# Technical Bulletin

TB-106714 / March 28, 2018

## New Software Available for Sonar Modules

<b>Product:</b>	000-13260-001; 000-11142-001; 000-12397-001
<b>Product Description:</b>	S5100; Sonar Hub; Structure Scan 3D
<b>Software Version:</b>	S5100 V3.0-59.1.72; Sonar Hub V8.0-59.1.72; Structure Scan 3D V4.0-59.1.72
<b>Effective Date:</b>	19 March 2018
<b>Inspect/Update Current Inventory:</b>	Yes

## S5100

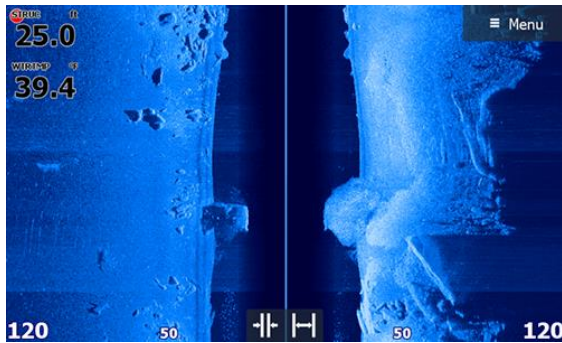
Improvements have been made to the sonar algorithms to improve target detection at low frequency. These improvements take effect in depths greater than 100m (300ft).

## StructureScan® 3D and StructureScan® HD

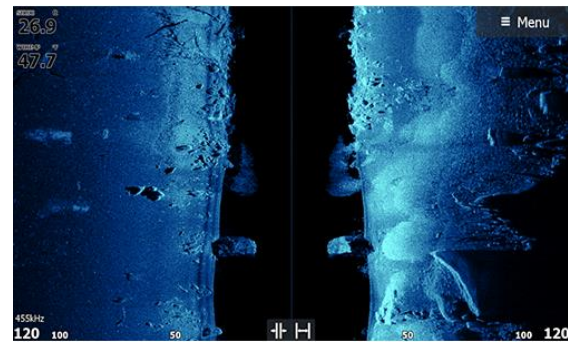
A new dynamic color range and tone strength result in high-visibility contrast never before seen in scanning fishfinders. A wider range of color enhances the quality of near-photographic images of SideScan, DownScan Imaging™ and StructureScan 3D/HD, showing more refined detail, more fish and dramatic bottom definition.
